Office Action Summary

10/719,245

PAUL T. CHIN

Exhibit B

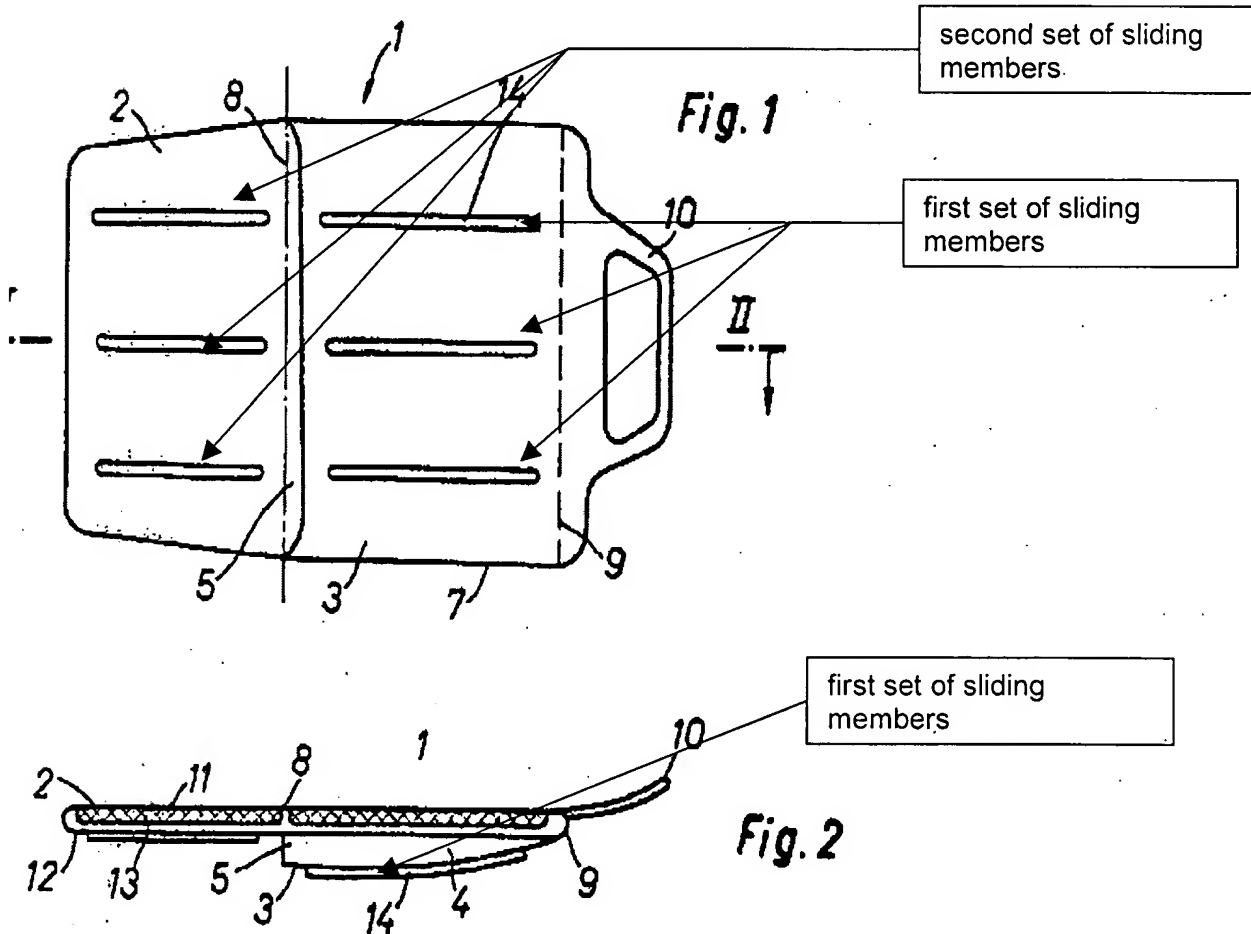
Re claims 2,3, and 20, Rickenbacher (4,170,367) (see Exhibit B) shows a first set of sliding member (14) and a second set of sliding member positioned between the front edge, a rear edge, and side ends wherein the first set is substantially larger (in length) than the second set of sliding members.

Re claims 21 and 22, Exhibit B (in figure 1), as best understood, shows that each sliding member has a perimeter having four arcuate segments and four junctures.

Exhibit A

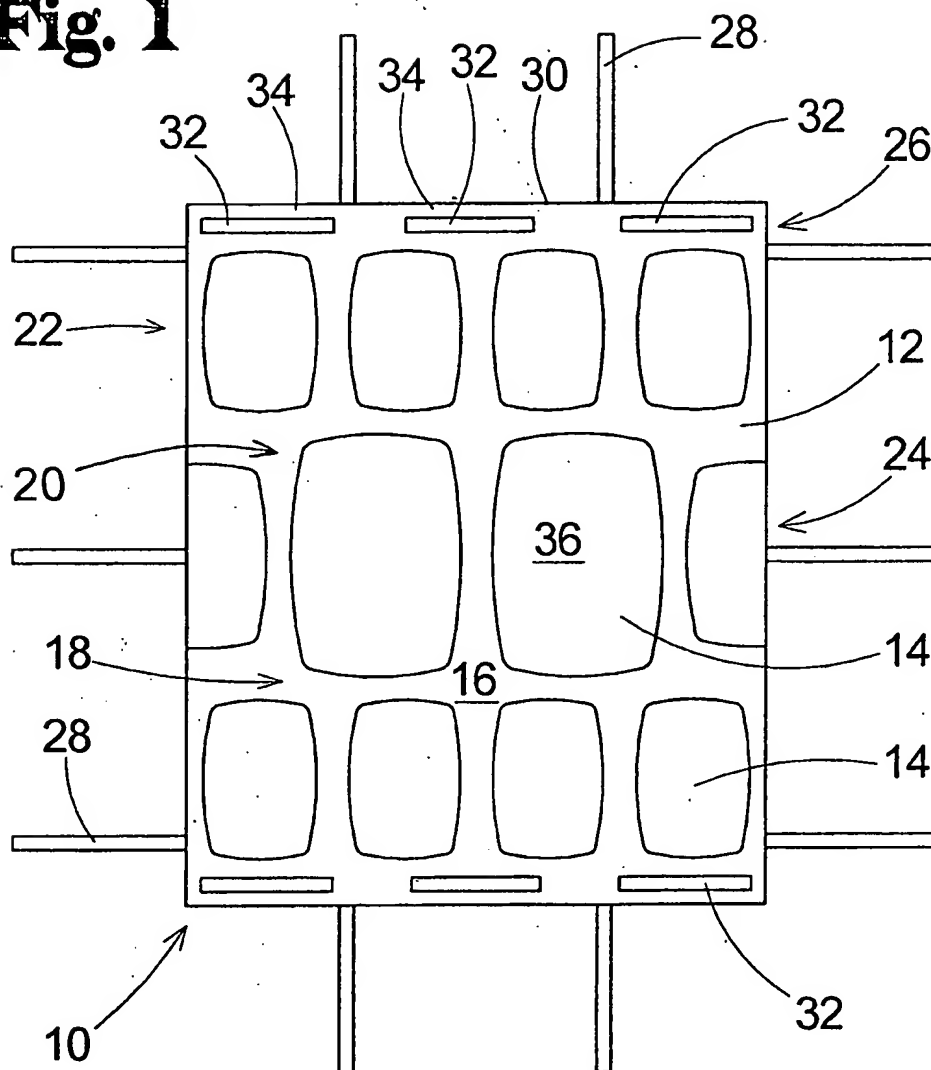
a sheet of material, made from a plastic material (col. 2, lines 44-48) having a lower face; a plurality of sliding members (14, 14) (Figs. 1 and 2) coupled to and protruding from (see Fig. 2) the lower face of the sheet of material being spaced each other to form

a grid of sliding members and each of the sliding member (14,14) has a substantially convex outer surface (see Fig. 2) for facilitating sliding on the support surface.

Exhibit C1

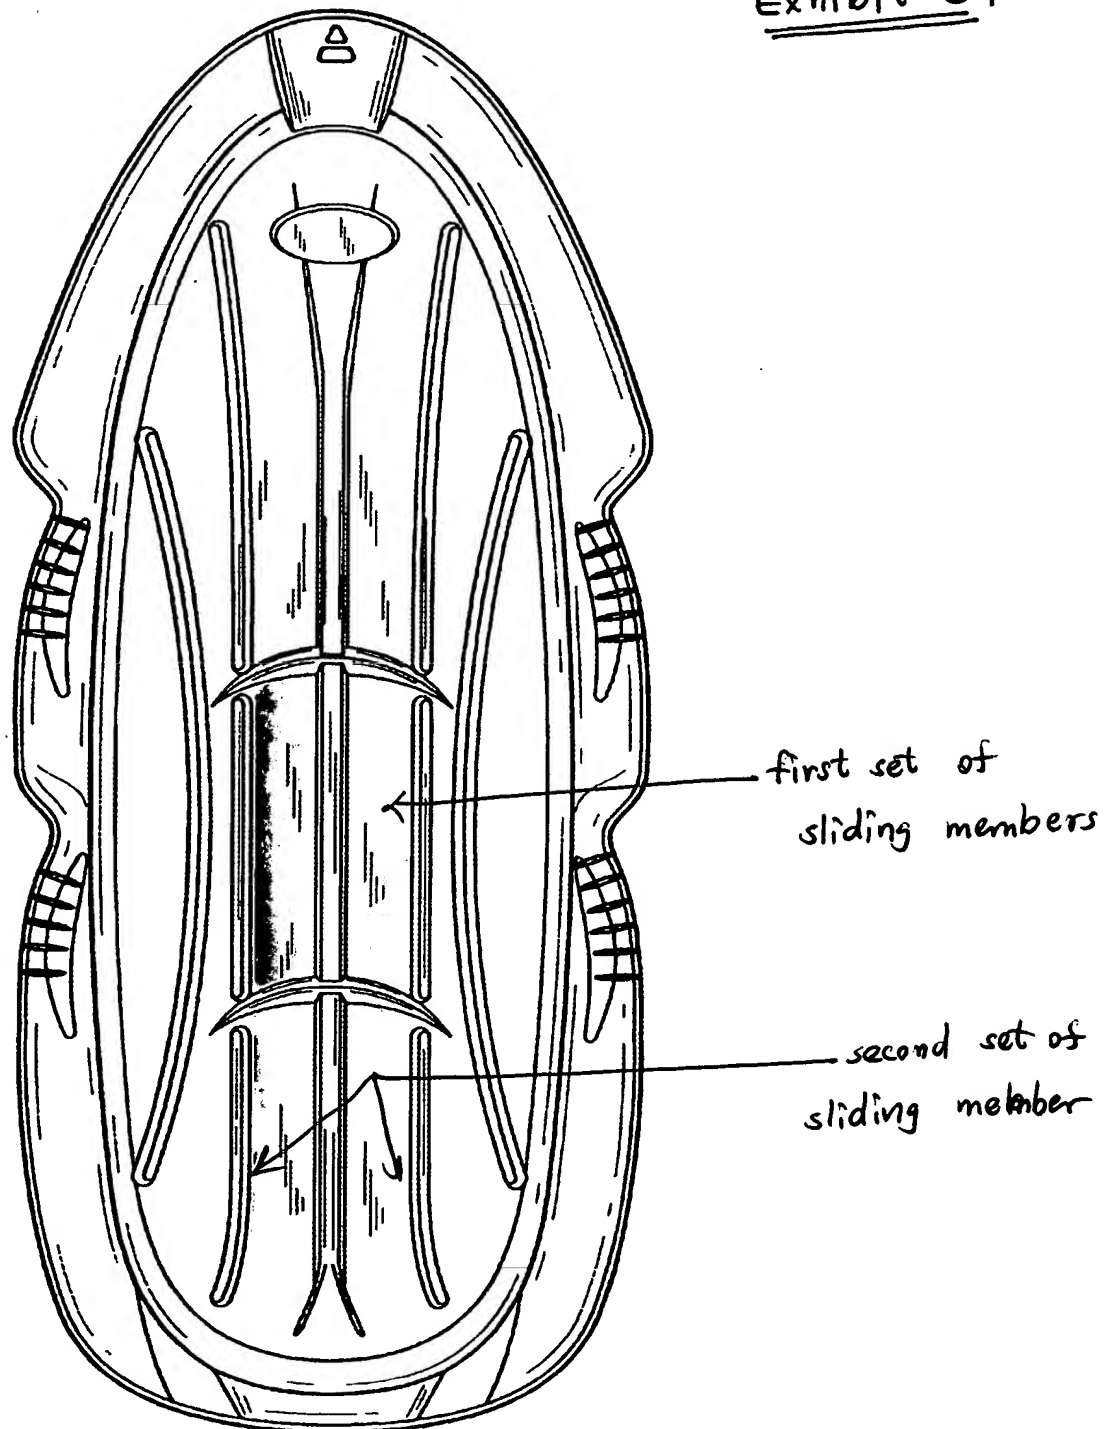
Eckert (D475,947) shows a sliding device comprising a sheet of material, having a lower face; a plurality of sliding members (see Fig. 3, bottom view) coupled to and protruding from (see Figs. 4 and 5) the lower face of the sheet of material being spaced each other to form a grid of sliding members and each of the sliding member has a substantially convex outer surface (see Figs. 4 and 5) for facilitating sliding on the support surface. Re claims 2,3, and 20, Rickenbacher (4,170,367) (see Exhibit C1 and C2, attached) shows a first set of sliding member (highlighted with orange color) and a second set of sliding member positioned (highlighted with yellow color) between the front edge, a rear edge, and side ends wherein the first set is substantially larger than the second set of sliding members.

Re claim 4, Exhibit C1 shows that the second set of sliding members surround the first set of sliding members.

Re claims 21 and 22, Exhibit C1 and C2, as best understood, show that each sliding member has a perimeter having four arcuate segments and four junctures.
